State of New Mexico
Energy, Minerals and Natural Resources

Form C-103
Revised August 1, 2011

WELL API NO. 30-025-30345
5. Indicate Type of Lease STATE <input checked="" type="checkbox"/> FEE <input type="checkbox"/>
6. State Oil & Gas Lease No. B10272
7. Lease Name or Unit Agreement Name WEST DOLLARHIDE QUEEN SAND UNIT
8. Well Number 136
9. OGRID Number 309777
10. Pool name or Wildcat DOLLARHIDE QUEEN (018810)

13. Describe proposed or completed operations. (Clearly state all pertinent details, and give pertinent dates, including estimated date of starting any proposed work). SEE RULE 19.15.7.14 NMAC. For Multiple Completions: Attach wellbore diagram of proposed completion or recompletion.

**WELLBORE DIAGRAM
WEST DOLLARHIDE QUEEN SAND UNIT #136
PROPOSED**

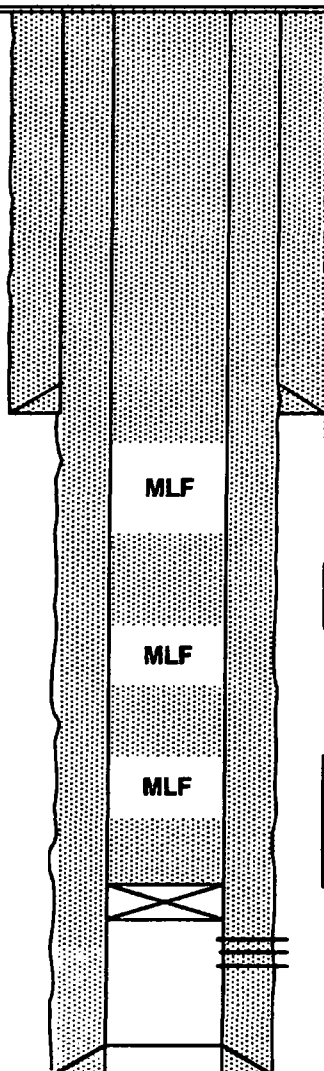
**SPOT 55SX OF CMT FROM 456'-SURFACE.
VERIFY. (FW/SHOE/SURFACE)**

**SPOT 25SX OF CMT FROM 1250'-1100'.
WOC&TAG. (T.SALT)**

**SPOT 35SX OF CMT FROM 2725'-2405'.
WOC&TAG. (YATES/B.SALT)
SET CIBP@3550' AND SPOT 25SX ON TOP
FROM 3550'-3300'.(PERFS)**
